CHAVIS SUBDIVISION

APPLICATION NUMBER 2 DATE June 3, 2010

REQUEST Subdivision

DETAIL SITE PLAN

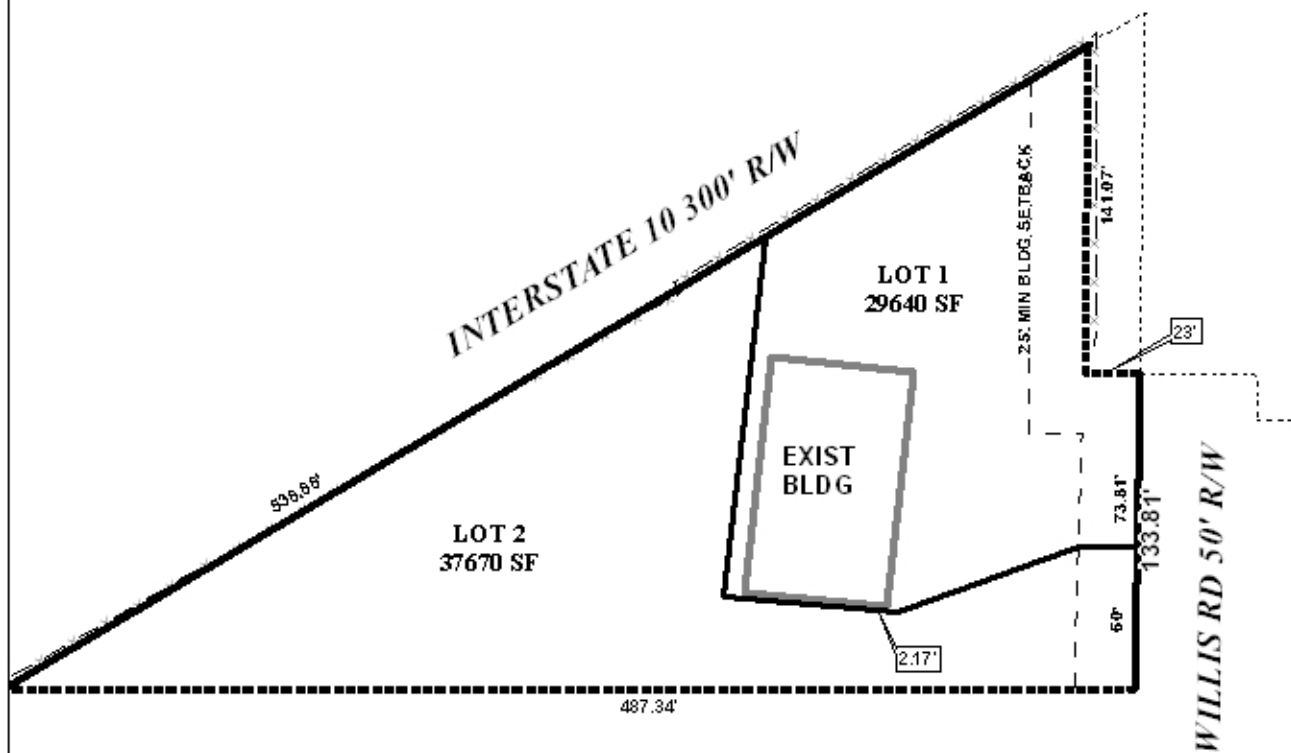
It should be pointed out that there is an existing structure on the site; however, the structure is not depicted on the preliminary plat. Staff is not able to determine if the proposed internal lot line will create a side yard setback issue as it relates to the Zoning Ordinance. The plat should be revised to depict the existing structure and the setback from the proposed internal lot line.

Staff met with the applicant and surveyor concerning the subdivision and a revised plat was later submitted illustrating the existing building on the site. The proposed internal property line is shown with a compliant 10' rear setback off the building; however, the side setback is indicated to be 2.17'. Since the subject property is zoned I-1, Light Industry, the Zoning Ordinance does not require a side yard setback, but if a side yard is provided, it must be at least 5'. Therefore, the proposed side yard setback is not compliant. The building has three service bay entrances, one of which is approximately 10' from the proposed side property line. As the proposed side property line is indicated to turn just past the front of the building and sharply angle across the front of the property, proper access and maneuvering area for the service bay closest to the proposed side property line may be insufficient.

As the proposed subdivision would still create a flag and the proposed internal property line would not meet the required side yard setback off the existing building as per the Zoning Ordinance, this application is recommended for denial for the following reasons:

- 1) no evidence was submitted to show that a flag lot is necessary to allow the site owner reasonable use of the site or to alleviate a situation that would otherwise cause extreme hardship as per Section V.D.1. of the Subdivision Regulations;*
- 2) no evidence of a family subdivision was submitted as per Section V.D.1. of the Subdivision Regulations;*
- 3) the flag lot would be out of character with other lots in the vicinity as per Section V.D.1. of the Subdivision Regulations; and*
- 4) the proposed internal property line would not meet the required side yard setback off the existing building per Section 64-4.D.2. of the Zoning Ordinance.*
